Kimberly Design(New)

7th June 2017

Observations

3 **Observations: Child Care & Training Center**

C1 type column

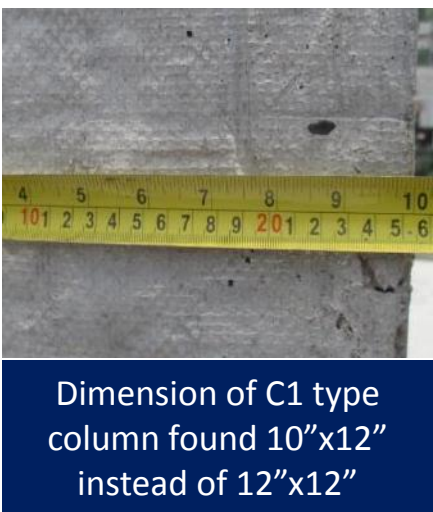
Dimension of C1 type column found 10"x12" instead of 12"x12"

Depth of stair case beam was found 1 inch less then provided drawing

Item No.	Observation	Recommended Action Plan	Recommended Timeline
1	(Child Care & Training Center) Discrepancies between drawings and On-site observation	Building engineer to survey the whole building and produce as-built documentation reflecting the as constructed condition.	6-weeks
2	(Child Care & Training Center) Corrosion observed on the exposed reinforcement of roof	Building Engineer is required to investigate the extent of corrosion and suggest necessary repairing action.	6-weeks
3	(Child Care & Training Center) Corrosion observed on the exposed reinforcement of roof	Implement repairing works as per engineer's advice.	6-months
4	(Wastage Room) Missing information in provided drawing	Building engineer to survey the whole building and produce as-built documentation reflecting the as constructed condition.	6-weeks
